DEPARTMENT OF ENVIRONMENTAL PROTECTION  
Mail Code – 401-02B  
Water Pollution Management Element  
Bureau of Surface Water & Pretreatment Permitting  
P.O. Box 420 – 401 E State St  
Trenton, NJ 08625-0420  
Phone: (609) 292-4860 / Fax: (609) 984-7938

Re: Review of Selection and Implementation of Alternatives Report (SIAR)  
City of Camden, NJPDES Permit No. NJ0108812  
City of Gloucester, NJPDES Permit No. NJ0108847  
Camden County Municipal Utilities Authority (CCMUA), NJPDES Permit No. NJ0026182

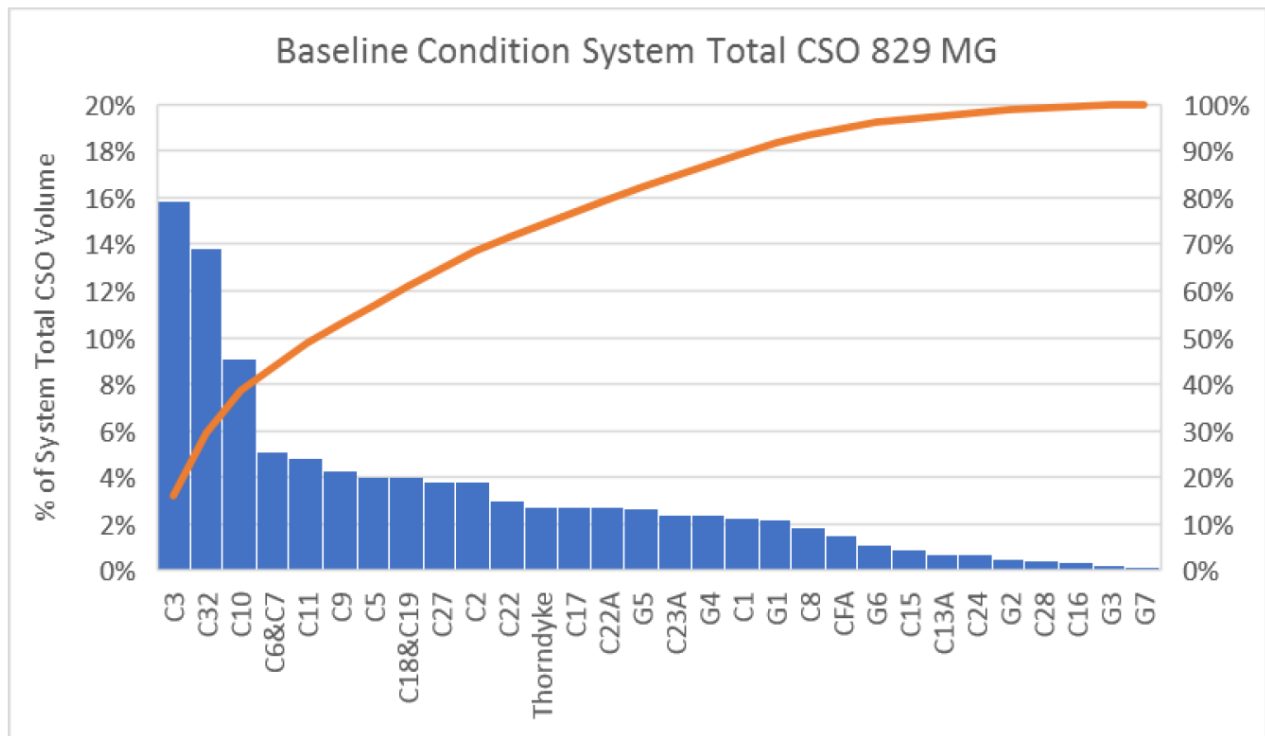
Comment 12: Section 5.1, Additional Control Requirements states the following regarding the Delaware River backchannel subsystem:

“CCMUA proposes to achieve 85% capture in the Delaware River backchannel subsystem through the reduction of wet weather flows from Pennsauken Township and increasing the wet weather flow rates through the Baldwins Run pump station.”

Due to their hydraulic isolation (varies pump stations) from the WPCF #1, the Delaware River – Gloucester City, the Delaware River Back Channel and the Cooper River sub-systems would not achieve increased capture with the potential expansion of the plant treatment capacity. The hydraulic limitations in the existing Camden and Gloucester interceptor sewers preclude the conveyance of additional wet weather flows to WPCF #1...”

Currently, the overflow from the combined sewer system from the C-32 sewershed is discharged through this CCMUA outfall into the Delaware Back Channel which is an important ecosystem that would benefit from protection through a reduction in CSO flow. In addition, the Department is aware that these combined stormwater and sanitary flows that come from Pennsauken take up needed capacity within the Camden combined sewer system. The cost of this project is estimated at \$43.3 million as per Section 5.3.3, Permittee Specific Cost Estimates. The location and hydraulic connection of this project within the system mean that it could occur independently from projects related to the restoration of the Camden combined sewer system and it is stated elsewhere in the report that this project would significantly reduce flooding in the Cramer Hill neighborhood. In addition, C-32 comprises a significant portion of the system-wide CSO flow in the CCMUA/Camden/Gloucester system, as per Figure 7-1, Percentage of System Total CSO for Each Outfall and Cumulative Distribution (Baseline Condition) of the June 2018 System Characterization Report:

Based on the above, please supplement this section with additional detail regarding the Camden-Pennsauken disconnect project including an explanation of which flows (i.e., stormwater, combined sewage) would be separated out and diverted to a direct outfall. In addition, please describe any stormwater or satellite treatment (i.e., disinfection) that would be incorporated. Finally, please provide a detailed schedule so that this project is prioritized to take place in the next five year permit cycle.
